**TOWN OF NEWBURGH  
PLANNING BOARD  
TECHNICAL REVIEW COMMENTS**

**PROJECT: MEADOW HILL ROAD EXPANSION (GOLDEN VISTA)**  
**PROJECT NO.: 2016-07**  
**PROJECT LOCATION: SECTION 60, BLOCK 1, LOT 9.1 & 9.2**  
**REVIEW DATE: 16 AUGUST 2016**  
**MEETING DATE: 18 AUGUST 2016**  
**PROJECT REPRESENTATIVE: JCM ENGINEERING**

**SITE GRADING PLAN**  
 MEADOW HILL ROAD EXPANSION  
 MEADOW HILL ROAD  
 TOWN OF NEWBURGH, NY

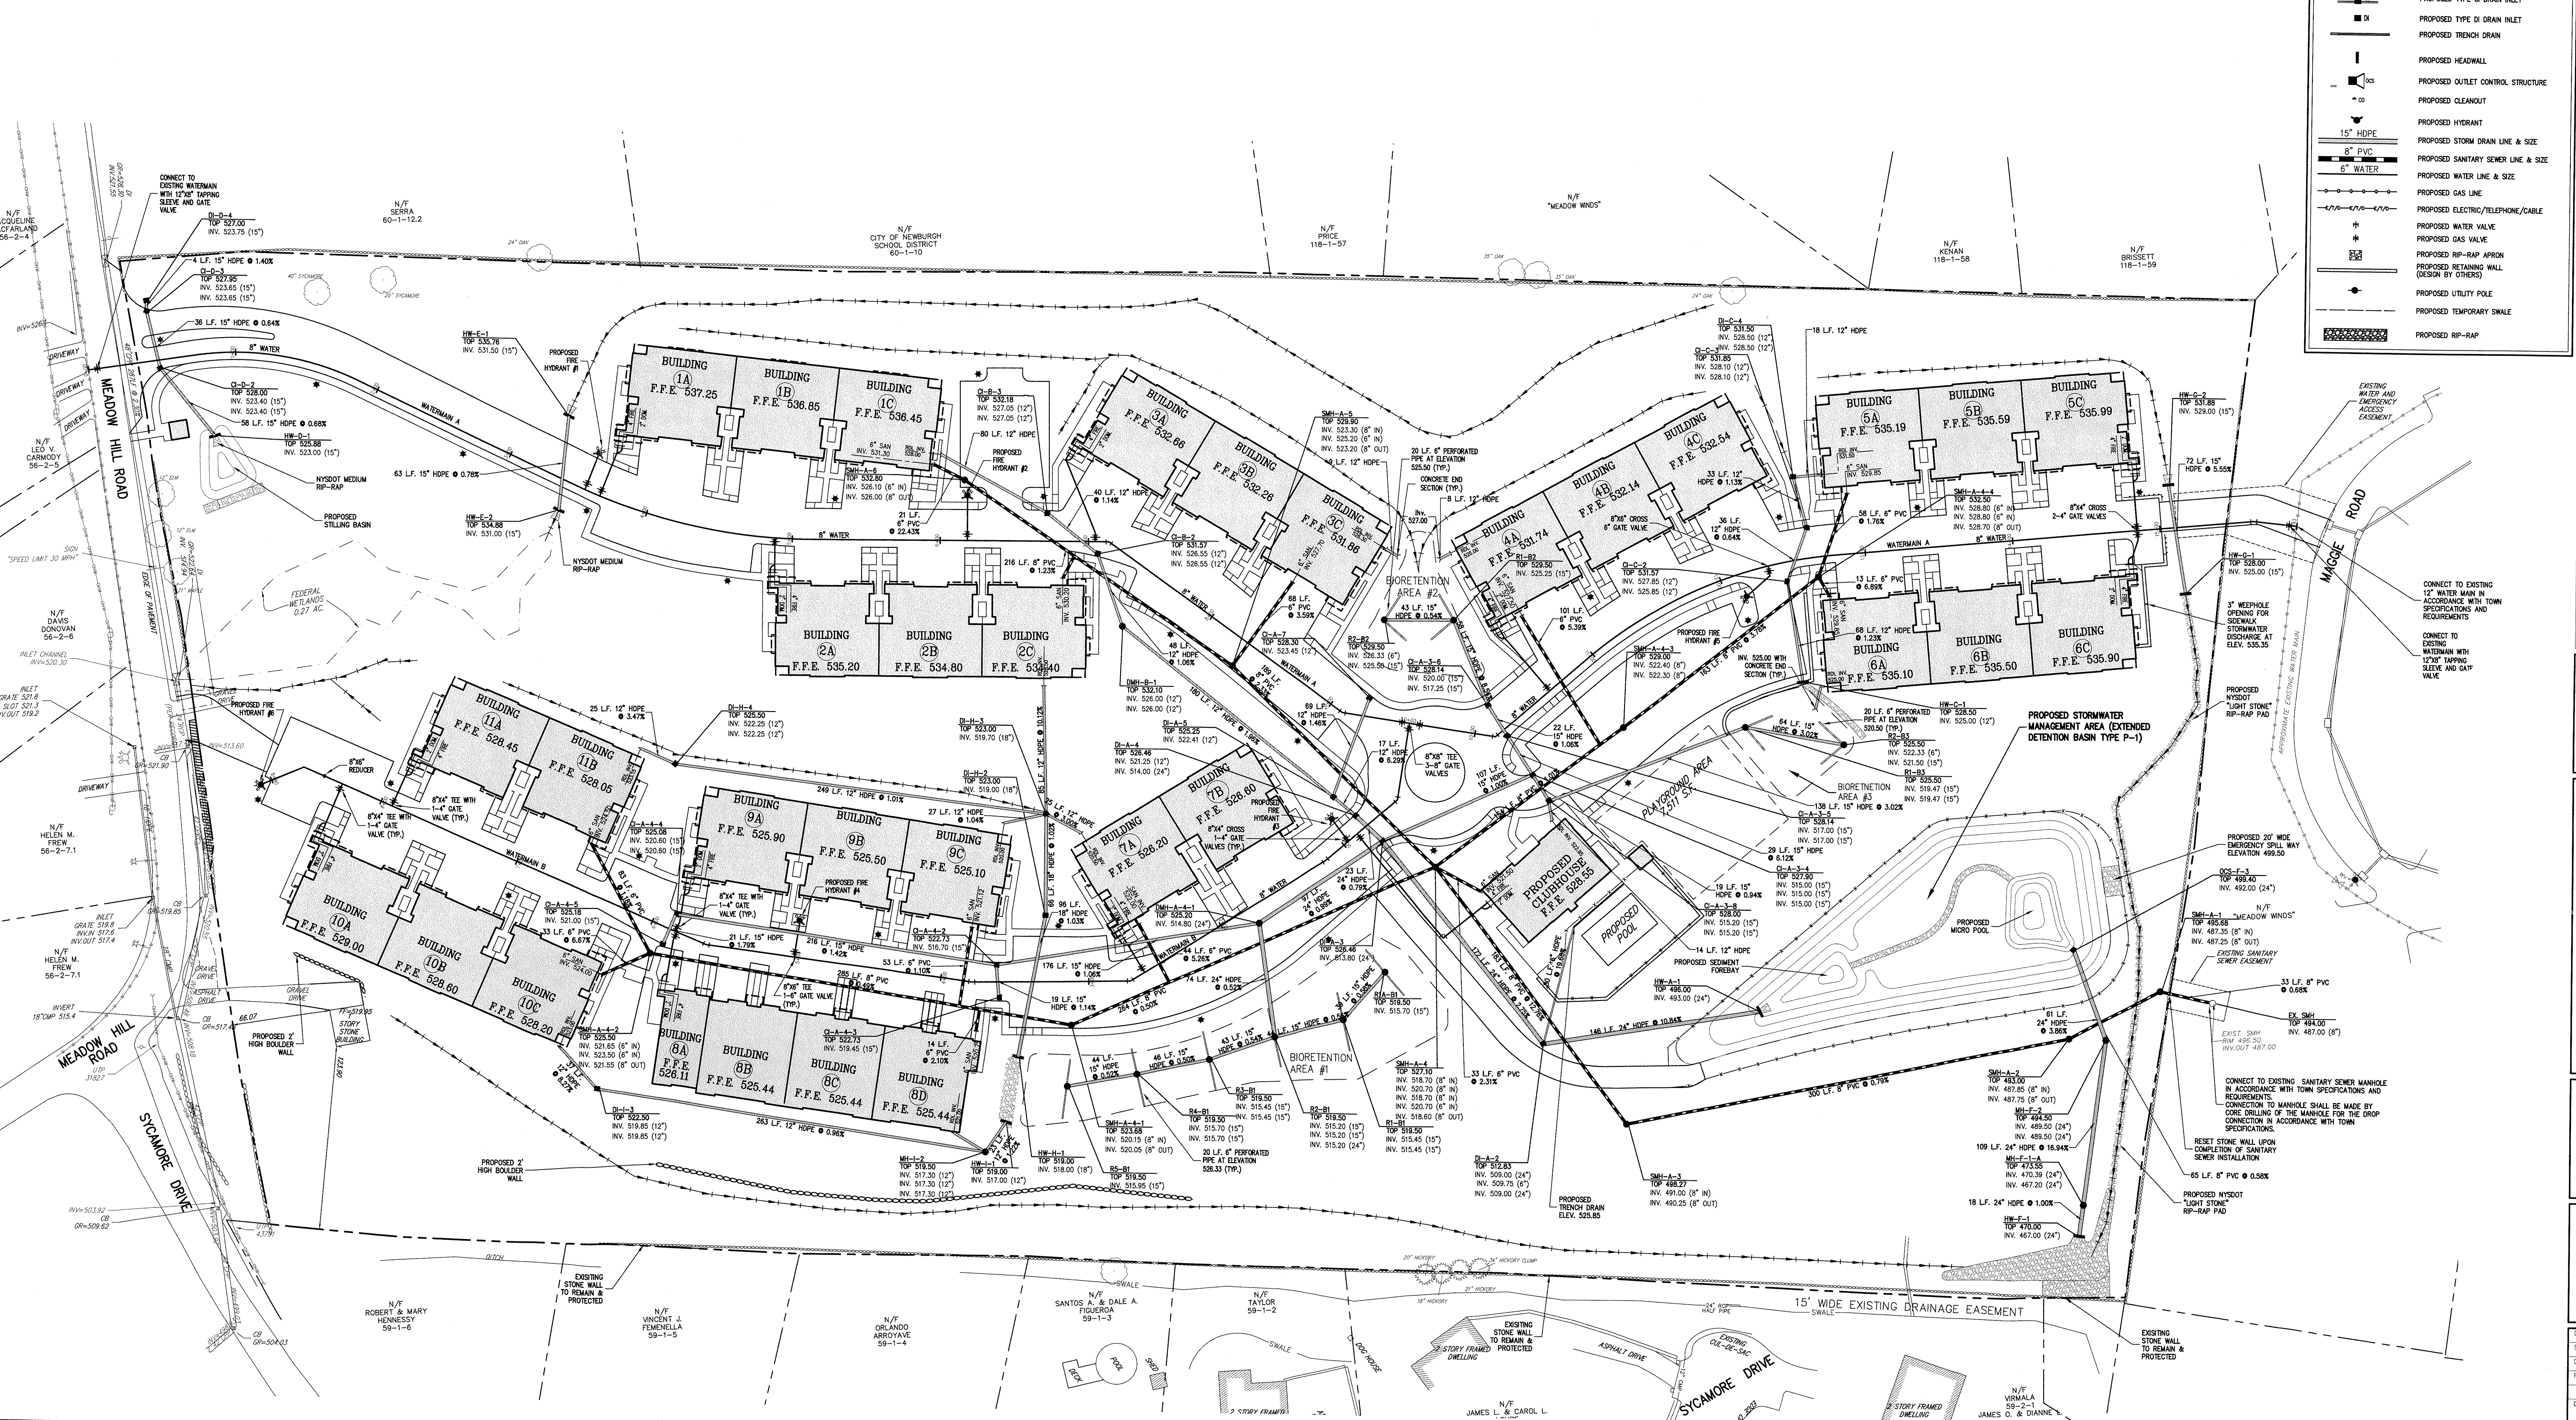
5. Lot consolidation must occur prior to filing of the maps.
6. The Applicants representative are requested to review the grading of the emergency access road to Maggie Road. Topography underlying the existing roadway does not reflect the proposed grading. Topography at the existing roadway is approximately 530 while a 524 grade line is depicted. Coordination of this proposed and existing topography should be performed to assure emergency vehicles can access the roadway.

7. The Planning Boards attention is called to the fact that the revised plans call for a modification raising the finished floor elevations on the site approximately 2.5 feet +/- to account for grade changes which will eliminate the need to transport excess material from the site.
